FORD 4R100 "UPDATE HANDBOOK"

FORD 4R100 "UPDATE HANDBOOK"

Since the introduction of the 4R100 transmission in model year 1998, there have been many engineering changes to improve Pleaseability, Reliability and Durability concerns. These changes have affected most every part used in this transmission. This "Update Handbook" will explain each change, the reason for the change, and any parts interchangeability concerns created by the change, along with any part numbers needed to update your transmission.

Figure 43

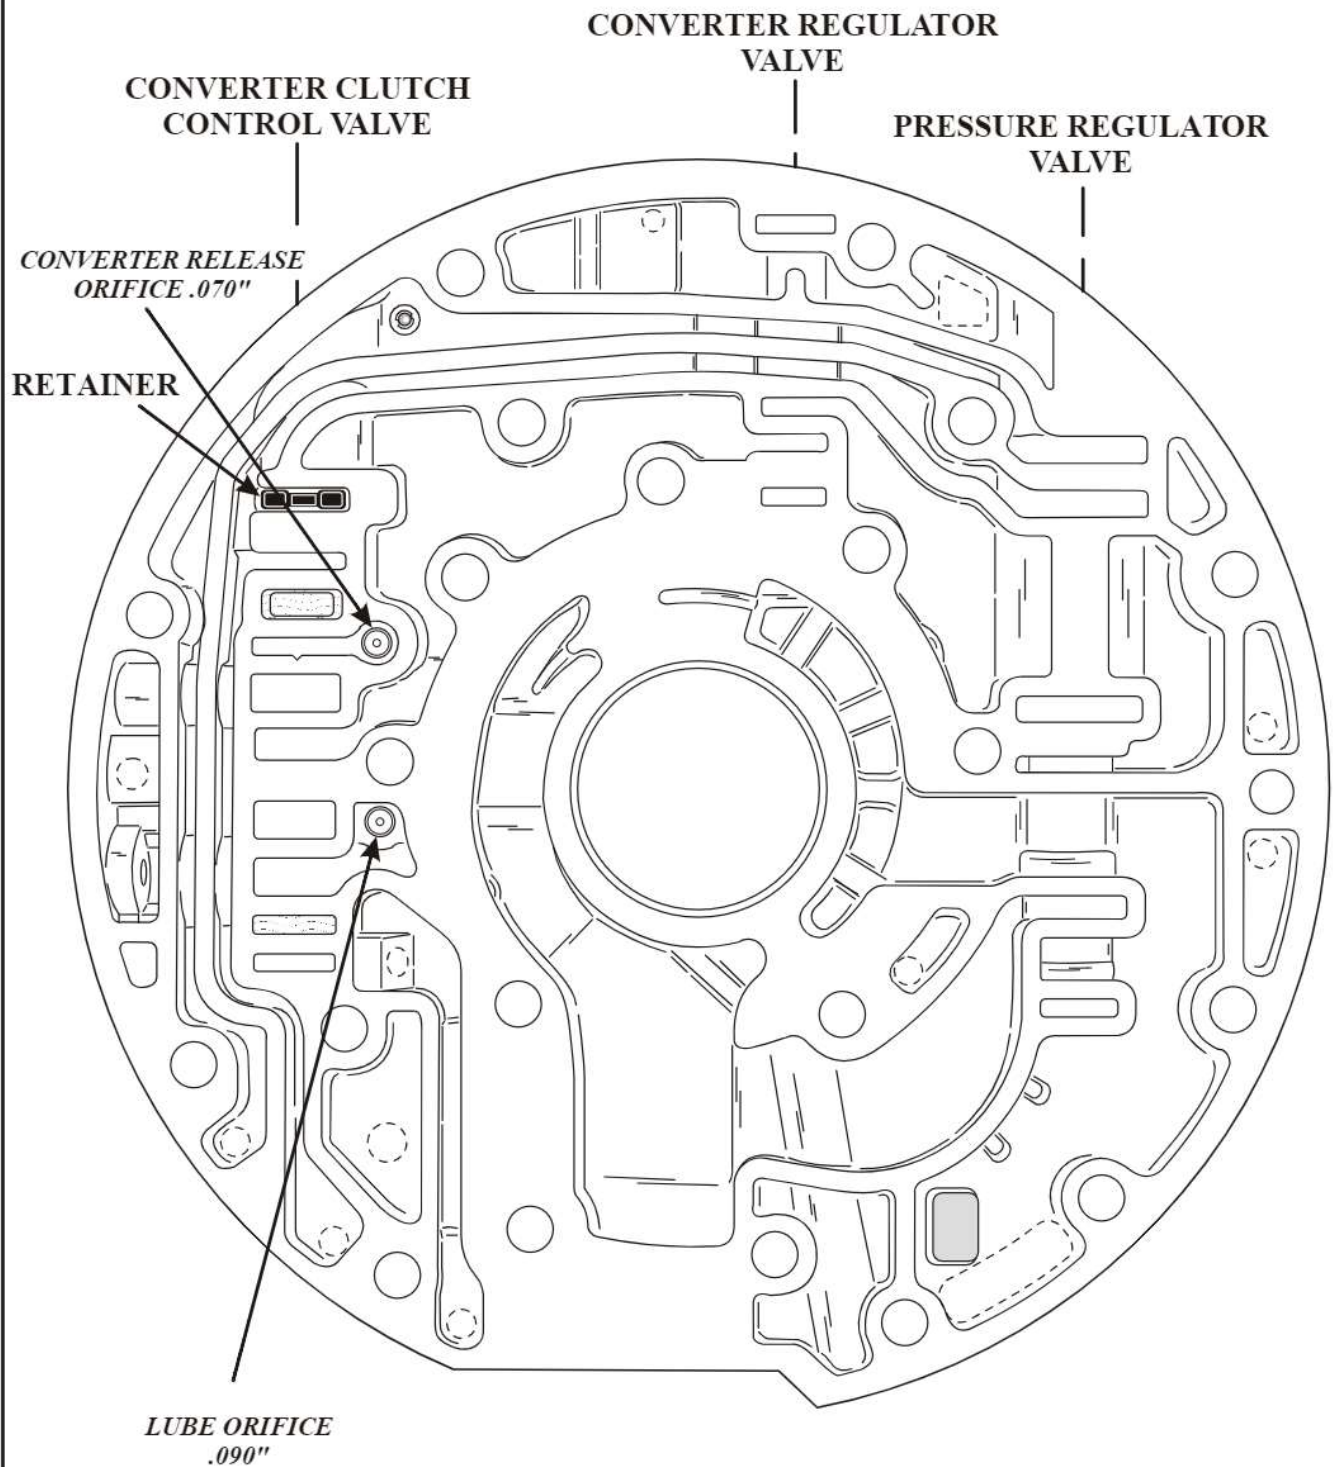
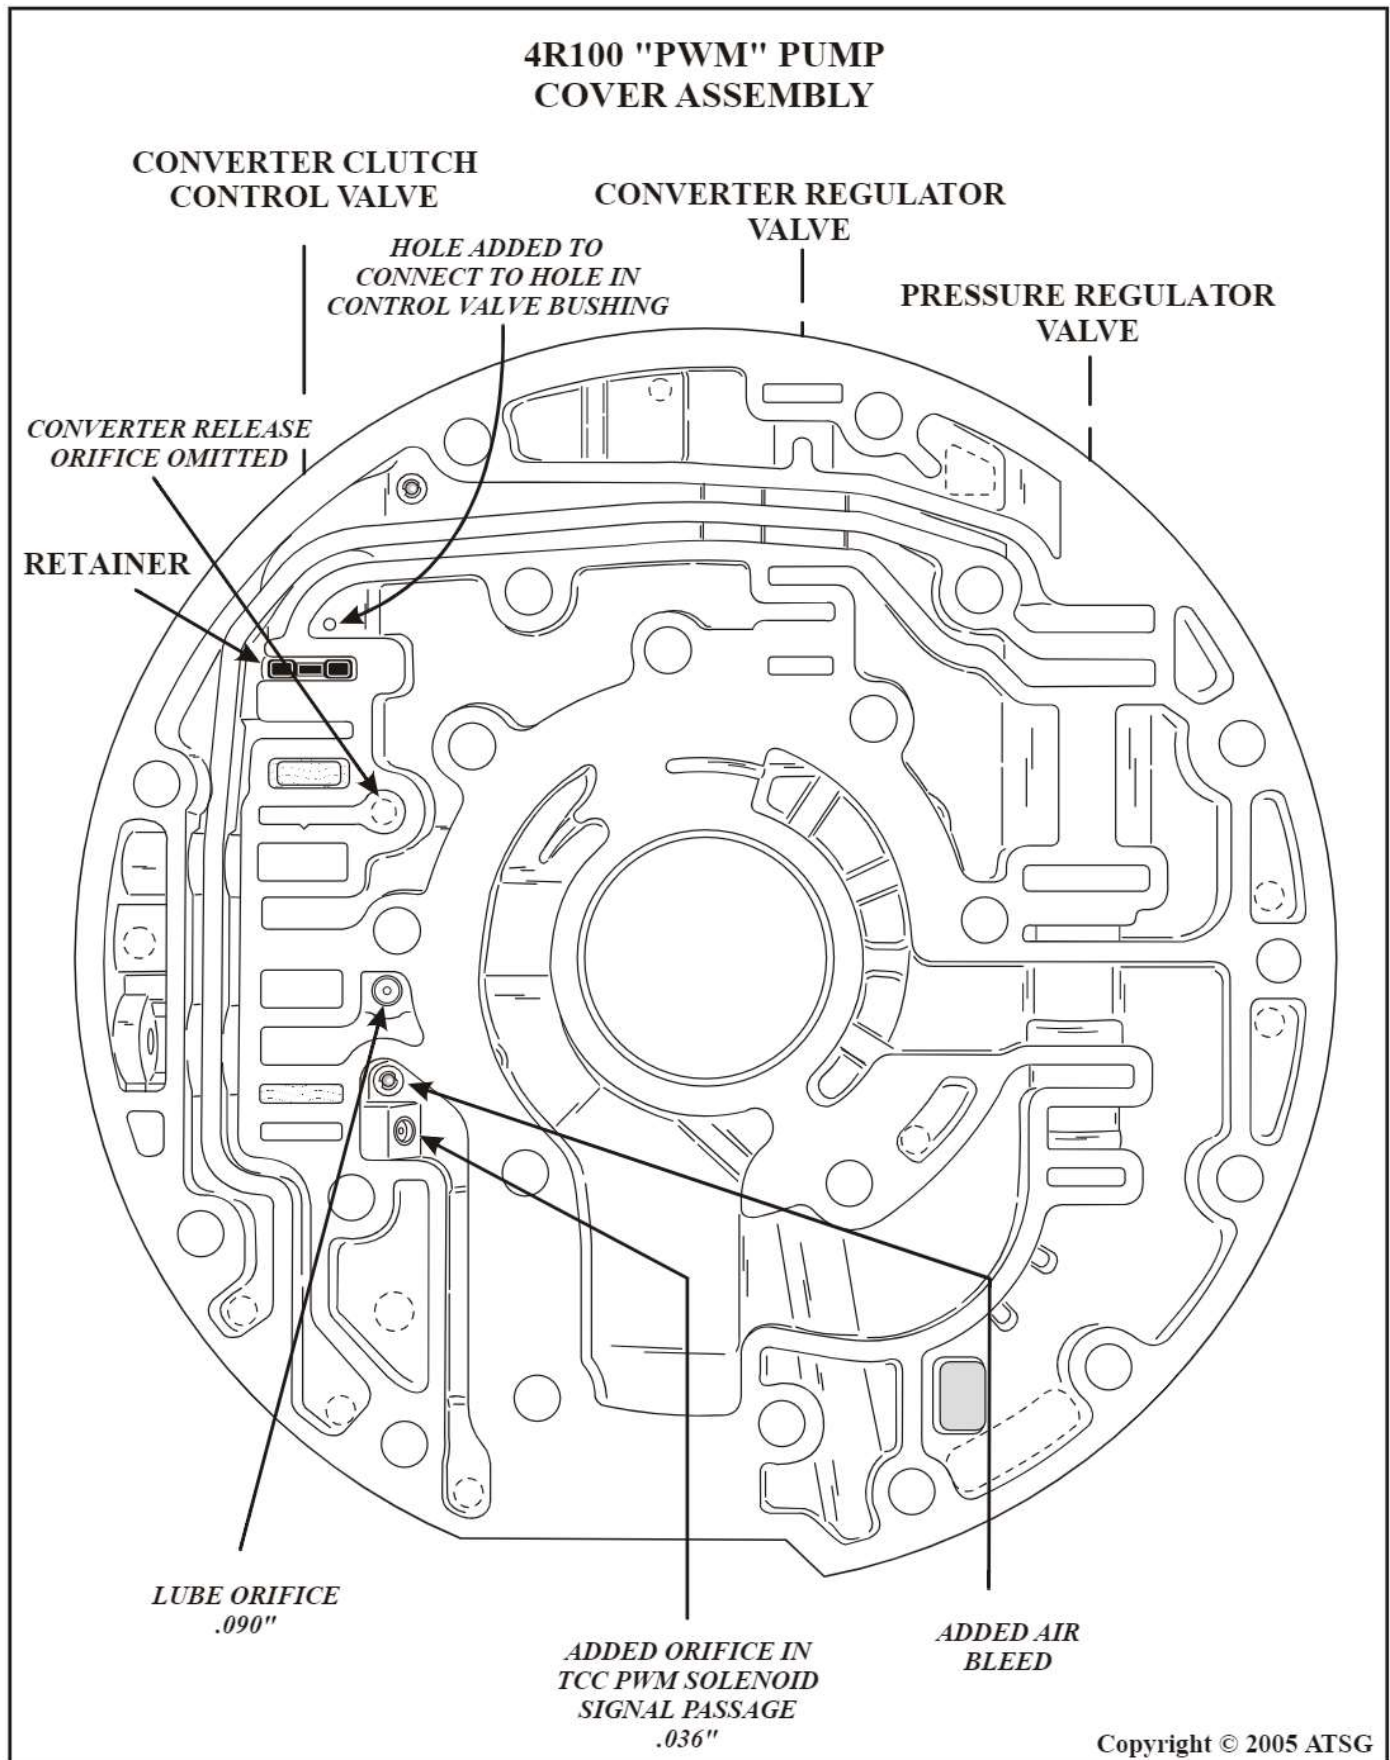
- The Converter release orifice in the NON-PWM pump cover, as shown in Figure 42, was removed from the PWM pump cover, as shown in Figure 43.
Refer to Figure 44 for the NON-PWM pump hydraulic circuit.
Refer to Figure 45 for the PWM pump hydraulic circuit with all hydraulic changes shown.

Figure 47

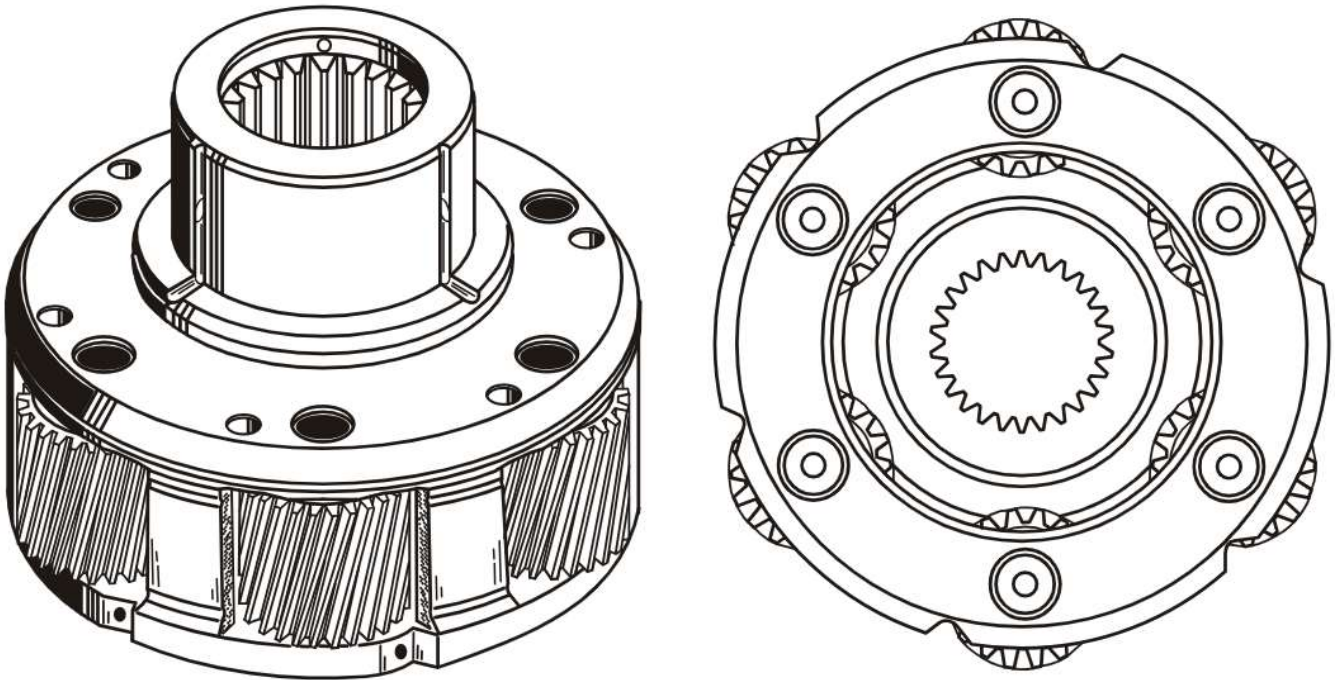
CHANGE: Beginning at the start of production for all 1998 model E4OD transmissions, *some models* will be equipped with a new design 6 pinion forward planetary carrier (See Figure 47), and a new design 6 pinion reverse planetary carrier (See Figure 48).

- (1) FORWARD PLANETARY CARRIER - Now has 6 pinions instead of the previous 4 pinions for increased torque carrying capacity and increased durability (See Figure 47).
- (2) REVERSE PLANETARY CARRIER - Now has 6 pinions instead of the previous 4 pinions for increased torque carrying capacity and increased durability (See Figure 48).

The new design forward planetary carrier *will back service all models* of the E4OD, but it *does require* the latest design forward ring gear hub and bearing assembly, as there are no holes for the previous design thrust washer (See Figure 47).

**NEW DESIGN 6 PINION FORWARD PLANETARY CARRIER
PART NUMBER F81Z-7A398-CA**

Figure 49

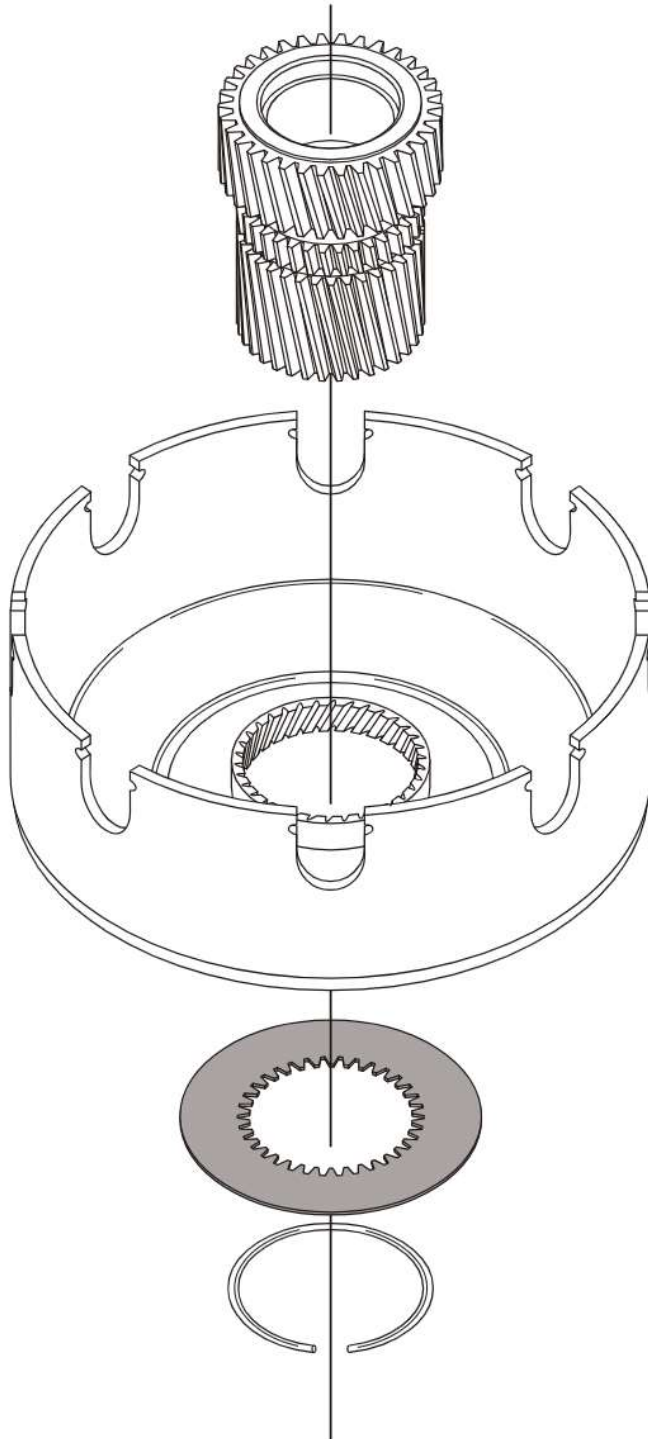
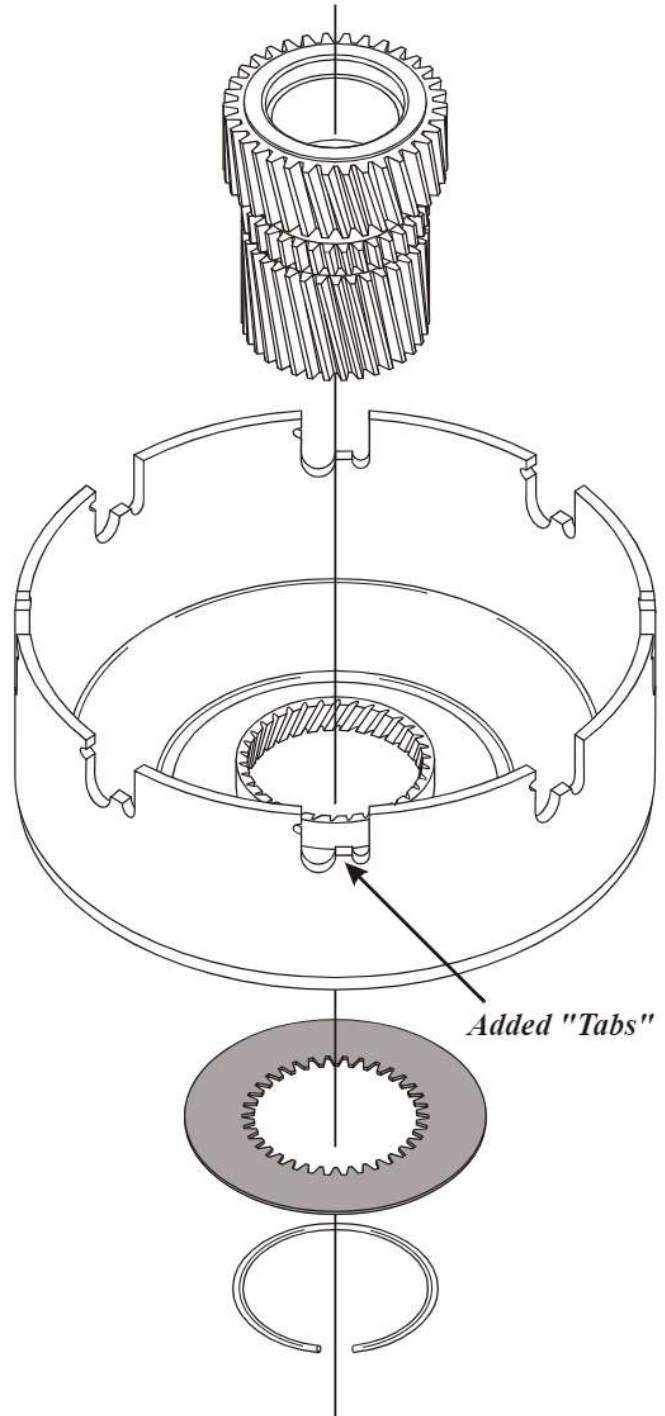
CHANGE: There is now a new design Sun Shell with "Tabs" added to the center of the sun shell slots, as shown in Figure 49, implemented by Ford Motor Co. as a running change, during the 2000 model year. This change eliminated the need for the number 8 thrust washer between the forward and direct drums.

- (1) INPUT SUN SHELL - New design have "Tabs" added to the center of the sun shell slots, as shown in Figure 49, which now support the direct drum for the required clearance between the direct and forward clutch housings, and allows elimination of the number 8 thrust washer, as shown in Figure 50.
- (2) DIRECT CLUTCH HOUSING - Manufactured "Without" slots in the center hub, as they were no longer needed to accept the number 8 thrust washer tabs. Both design direct drums are illustrated in Figure 50, and cut-away in Figure 51.
- (3) NUMBER 8 THRUST WASHER - Eliminated (See Figure 50 and 51).

PREVIOUS DESIGN SUN SHELL *"No Longer Available From Ford"*

*May Be Used With "ONLY"
The Previous Design Direct Drum
And Requires The No. 8 Washer
(See Figure 50)*

NEW DESIGN SUN SHELL *Hardened = YC3Z-7D064-BA Regular = YC3Z-7D064-AA*

*May Be Used With
Both Design Direct Drums
With Or Without Washer
(See Figure 50)*

Figure 53

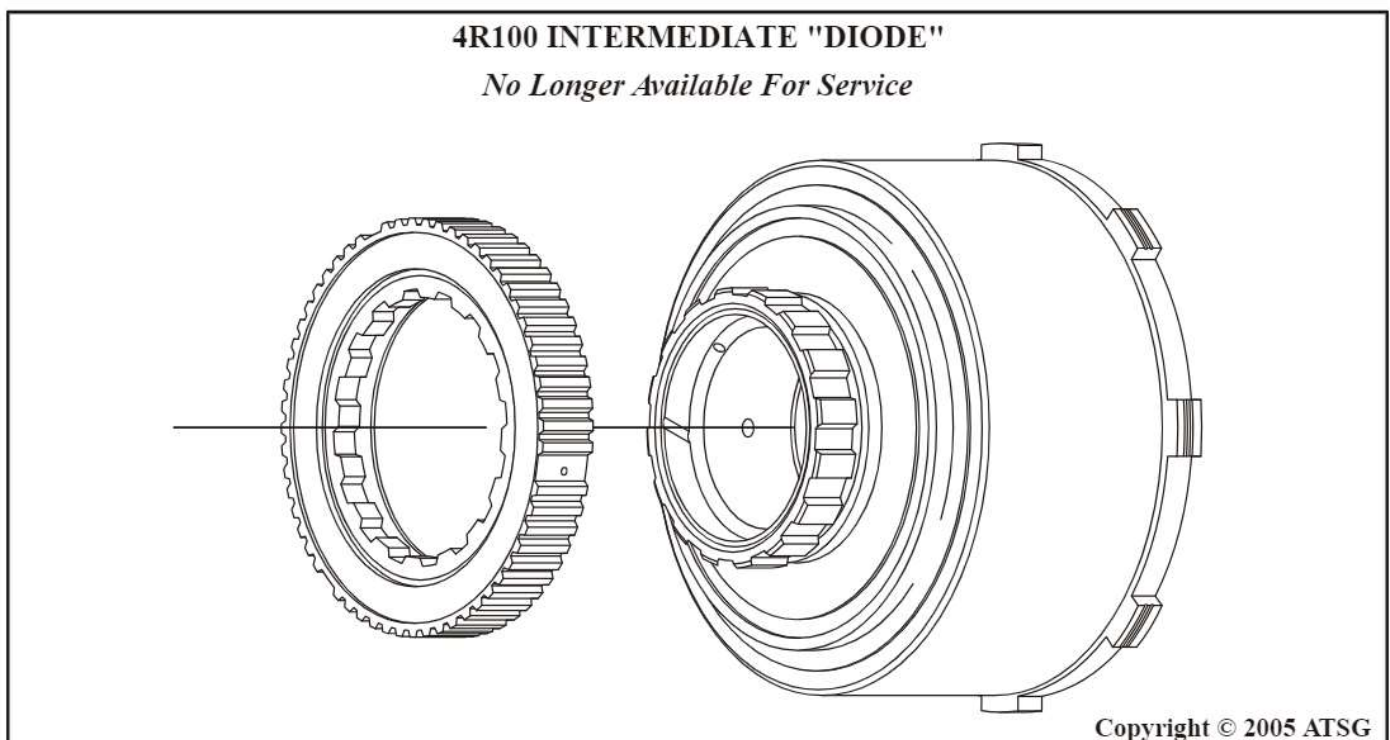
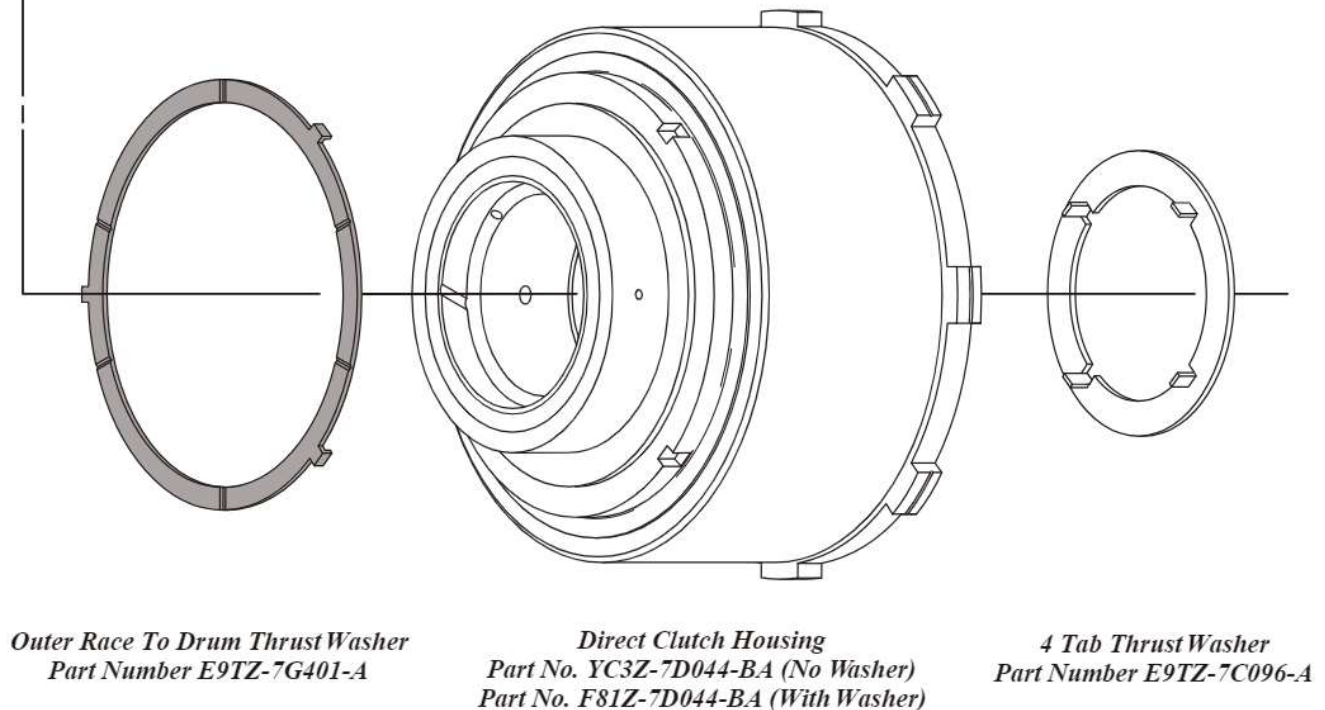
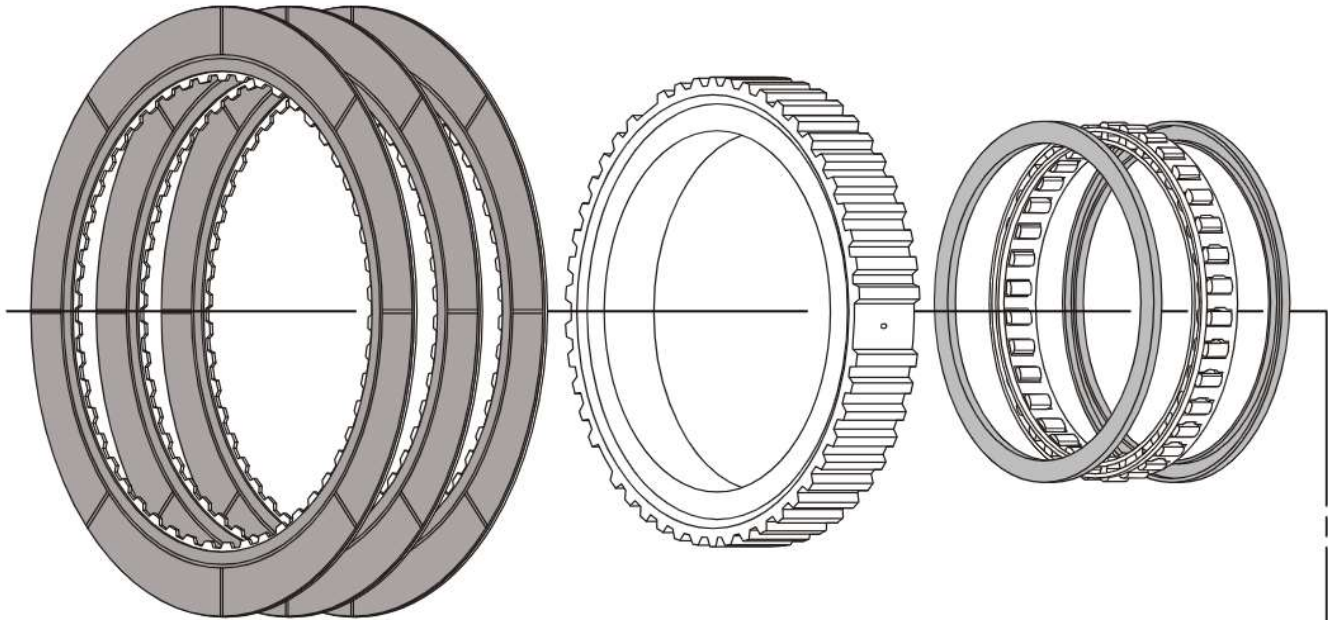
COMPLAINT: Some Ford Motor Company vehicles equipped with the 4R100 transmission may exhibit premature failure of the newly introduced Intermediate "Diode" Freewheel device that was installed in model year 2001 and illustrated in Figure 52.

CORRECTION: The Intermediate "Diode" is *no longer serviced* by Ford Motor Company. The part number now supercedes to all of the previous design level parts, which include the direct clutch housing, intermediate sprag assembly, outer race to direct drum thrust washer, and the intermediate friction plates. All of the previous design level parts are illustrated in Figure 53, with the OEM part numbers. The intermediate frictions must be replaced because the tooth count on the outer race between the diode and the sprag are different.

PARTS NEEDED TO REPLACE INTERMEDIATE DIODE

Intermediate Friction Plates
Part Number 1C3Z-7B164-BA
(Or Raybestos Plates OK)
(3 Required)

Intermediate Sprag Assembly
Part Number E9TZ-7A089-B
